THE ADMINISTRATOR OF THE ENVIRONMENTAL PROTECTION AGENCY

Thank you for your September 12, 2016, letter to U.S. Environmental Protection Agency Administrator Gina McCarthy transmitting on behalf of Southern Illinois Power Cooperative a petition for reconsideration regarding the EPA's July 12, 2016, final rule titled "Air Quality Designations for the 2010 Sulfur Dioxide (SO<sub>2</sub>) Primary National Ambient Air Quality Standard – Round 2" (81 FR 45039). In the petition SIPC requests that the EPA reconsider the nonattainment designation for the area surrounding Marion Power Station in Williamson County, Illinois, for the 2010 SO<sub>2</sub> Primary National Ambient Air Quality Standard.

**Enclosure A**  
**EPA Response to Petition for Reconsideration from**  
**Southern Illinois Power Cooperative**

Figure 1. Image of Illinois EPA receptor grid for the Northern Property area

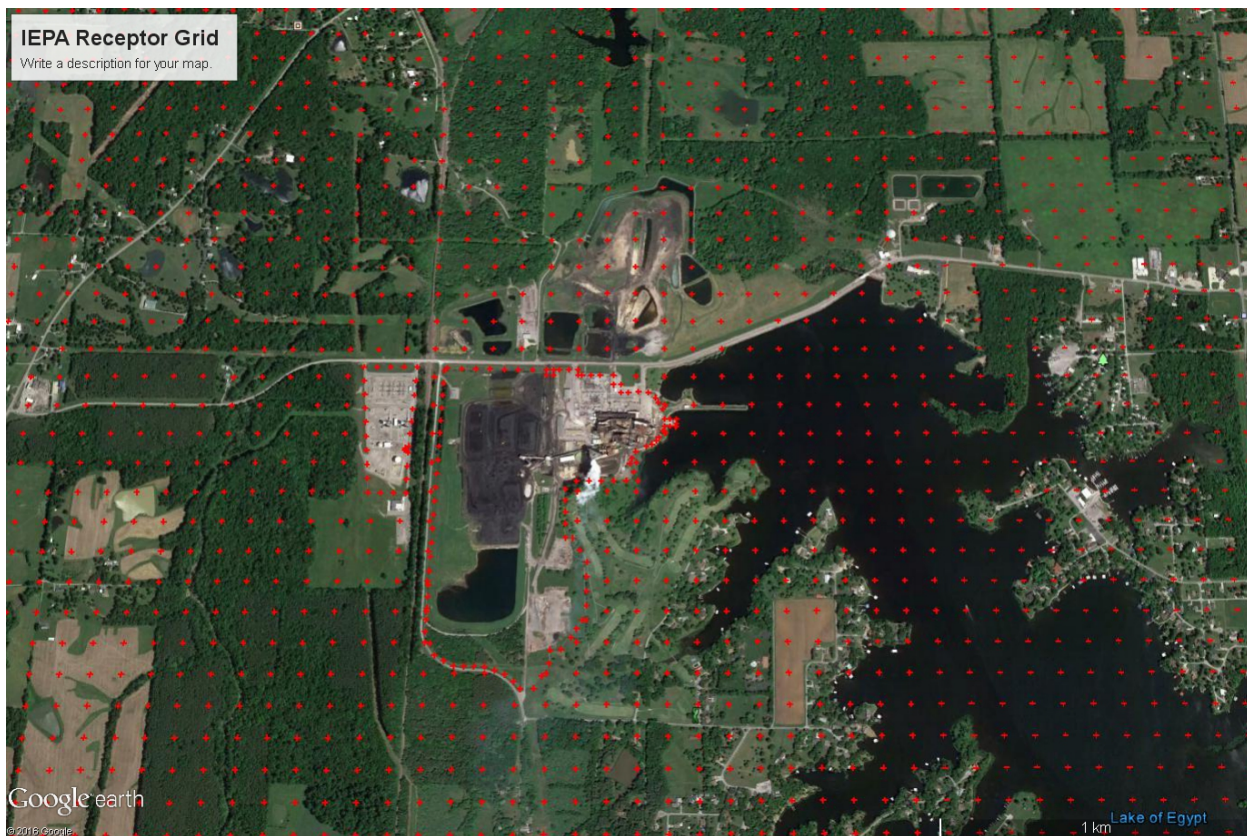
In this figure, red dots are used to indicate the locations of receptors in Illinois' modeling. The Marion power plant is in the center of this figure, and Lake Egypt Road runs east-west through the center of this figure. Thus this figure illustrates that Illinois used a regular grid of receptors in SIPC's property north of Lake Egypt Road, northeast of the plant.

In EPA's review and evaluation of SIPC's timely modeling and comments that implicitly disputed this aspect of the proposed designation, the EPA faced a choice in how to respond to SIPC's comment (and Illinois'): 1) finalize EPA's proposed view (that the area(s) were ambient air and receptors must be included) since neither SIPC nor Illinois provided necessary justification or supporting information to support exclusion, or 2) actively seek to obtain and examine other publicly available information not submitted to the EPA, such as information available from the internet, to determine whether the conclusory comments and associated modeling with such excluded receptor areas were supportable and able to be relied on for designations. The EPA undertook the latter, and explained in the final designation TSD for Williamson County its conclusions that these disputed modeling receptors were located in ambient air. Specifically, the EPA concluded that "the public has sufficient access to most of [the northern property] that the area should be considered ambient air," that "placing a monitor in that area . . . is fully feasible," and so "EPA finds that receptors should have been placed" in this area. *See* TSD for final designations, pp. 22 to 25 and 31-32.
